Subject: City of Oakdale 2011 System Statement Comprehensive Plan Amendment

Review File No. 20281-3

City of Oakdale Comprehensive Plan Amendment 2011 System Statement Amendment

Review File No. 20281-3, Council Business Item No. 2012-132

Figure 1. City of Oakdale Updated Future Roadway Improvements Map

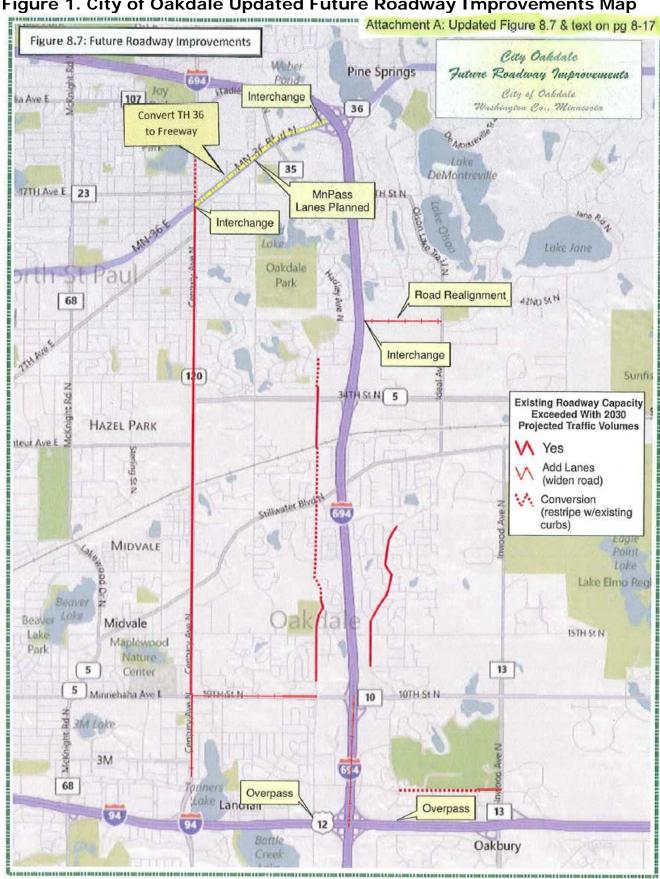
The proposed amendment conforms to the *2030 Transportation Policy Plan* (TPP). In response to the System Statement, the City edited Figure 8.7 (attached) in its transportation plan to remove the reference to an expansion of I-694 between I-35E and TH 36, and to add a MnPASS lane to TH 36. These changes are consistent with the System Statement.

Figure 8.7 shows additional roadway improvements that the City would like to pursue, and the Plan clearly states that these projects are not identified or funded in the TPP adopted by the Council in 2011. With this caveat clearly stated in both the text and on the map, the City may show these projects in its Plan.
